APPLICATION NO.	FILING DATE	FIRST NAMED INVENTOR	ATTORNEY DOCKET NO.	CONFIRMATION NO.
09/960,341	09/24/2001	Akihiro Komatsu	Q66198	4615
7590 01/04/2005 SUGHRUE, MION, ZINN, MACPEAK & SEAS, PLLC 2100 Pennsylvania Avenue, N.W. Washington, DC 20037-3202			EXAMINER GORDON, BRIAN R	
			ART UNIT 1743	PAPER NUMBER

Office Action Summary

DETAILED ACTION

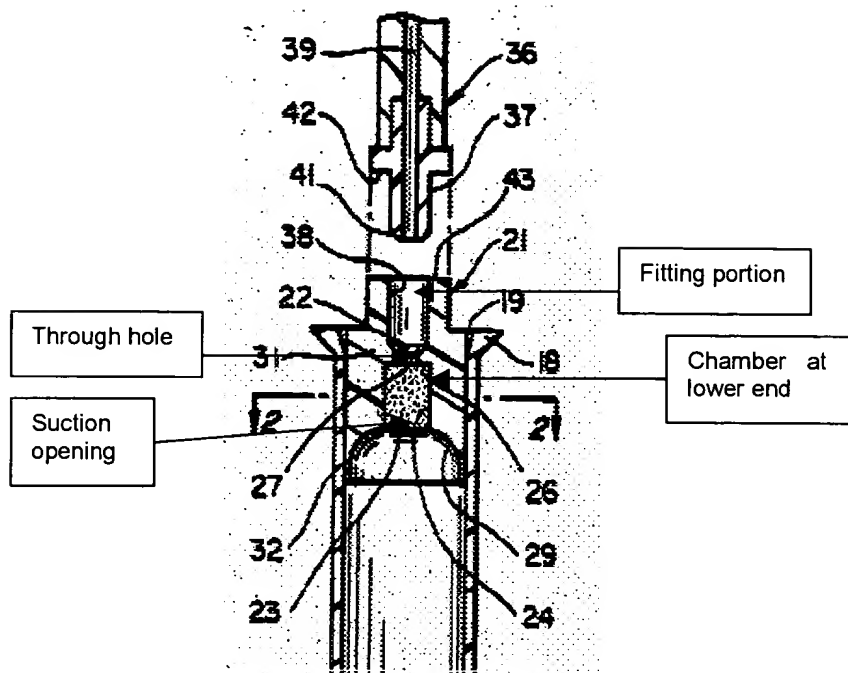
8. Claims 1-4 and 6-8 are rejected under 35 U.S.C. 102(b) as being anticipated by Mar US 4,644,807.

Mar discloses a device that is structurally equivalent to that as claimed by applicant (see figure below).

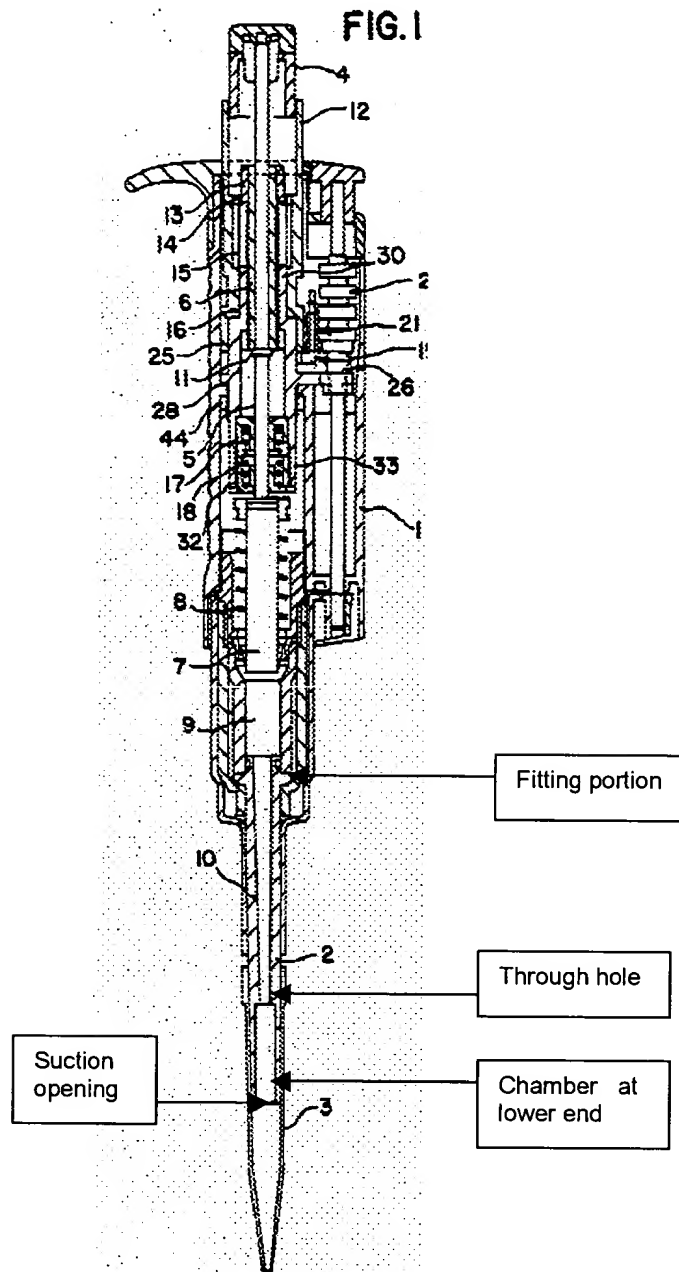
9. Claims 1-4, 6, and 8 are rejected under 35 U.S.C. 102(b) as being anticipated by Sabloewski, US 5,531,131.

Sabloewski discloses a device structurally equivalent to that as claimed by applicant as indicated by the figure below.

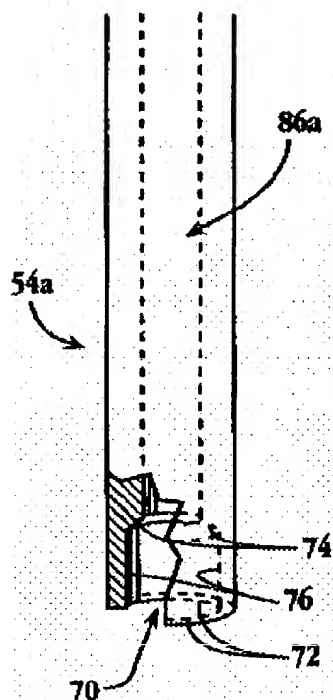
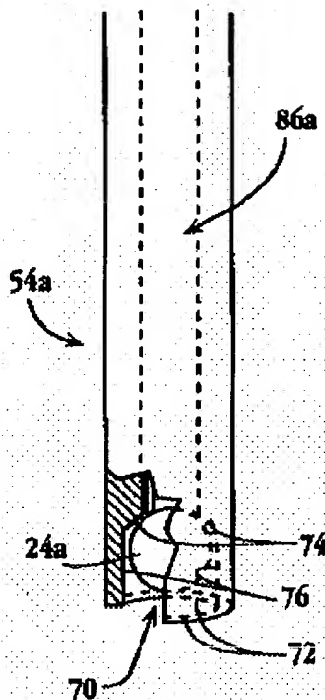
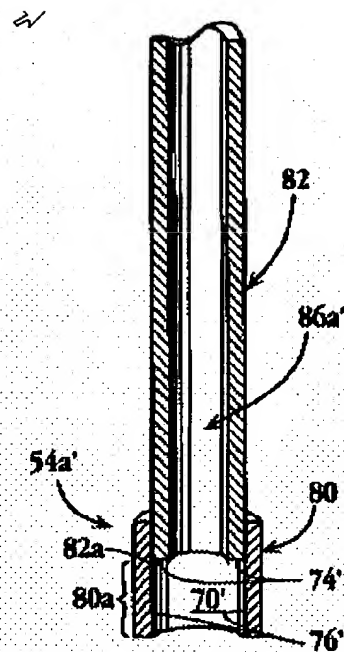
As seen in the figures above the projections (tips) have a lower cavity (chamber) of constant cross-sectional area terminating at an upper end with a through hole of a smaller cross-sectional area and the lower end has a hole that is equal to the cross-sectional area of the that of the cavity (see also figure 8).
